# 10GBASE-T TX\_NORMAL to SEND\_SLEEP Transition

Mike Grimwood, Broadcom

IEEE P802.3az Task Force

New Orleans, January 2010

# Figure 55-16b - EEE Transmit State Diagram (Changes in Blue)

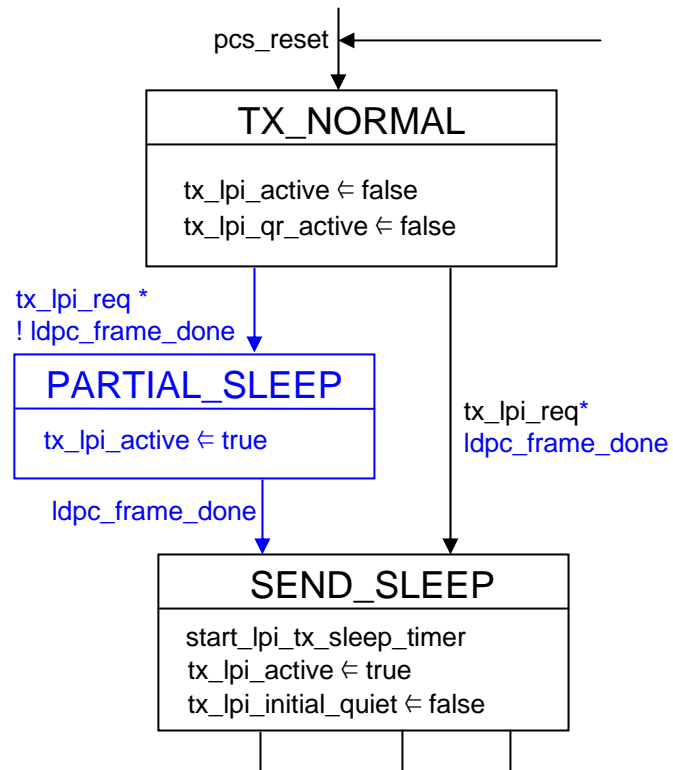
- Comment #24 submitted against IEEE P802.3az/D2.2 correctly notes that in the Figure 55-16b EEE Transmit State Diagram that the transition to the SEND\_SLEEP state should occur on a frame boundary.
- However, the suggested remedy does not handle a corner case in which an LPI client asserts and then immediately deasserts LPI such that the PHY transmits a partial frame of LPI and then there is a transition back to normal idles before the frame boundary is reached.
  - This results in LPI being signaled to the link partner, but the local device remains in the TX\_NORMAL state.
  - This would result in a wake failure since the link partner expects ALERT and WAKE signals that are not sent.
